From: Scala, Mary Joy
Sent: Monday, March 23, 2015 9:55 AM
To: ben@recs-va.com
Subject: BAR Action - March 17, 2015 - 731 W Main Street

RE: Certificate of Appropriateness Application
BAR 15-03-01
731 West Main Street
Tax Parcel 320145000
Benjamin Myrtle, Applicant/ Margaret Gibson, Owner
Window Replacement

**CITY OF CHARLOTTESVILLE
BOARD OF ARCHITECTURAL REVIEW
STAFF REPORT
March 17, 2015**

Window Replacement

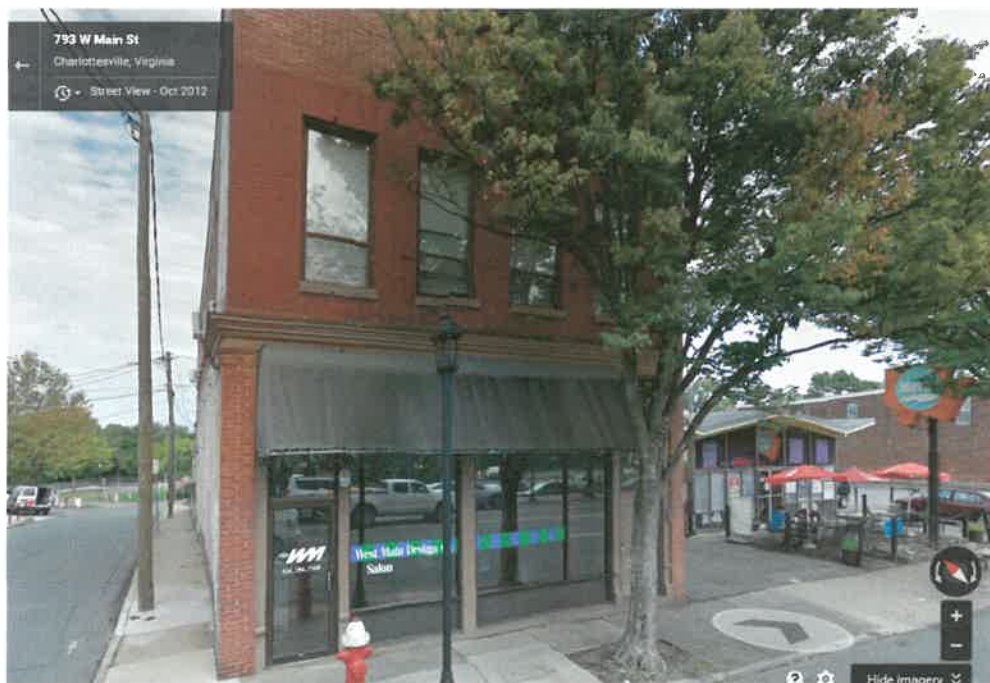
In this case, the existing windows are known to be modern.

Aluminum replacement windows would be appropriate. The BAR should confirm that the existing masonry openings will not be changed in size; that the windows will be 1/1 (no muntins); that the glass will be clear; and the proposed aluminum color should be confirmed.

The BAR approved (4-1 with Miller opposed) the window replacement as submitted, with 1/1 configuration (no divided lites); clear glass; and no change in the masonry openings.
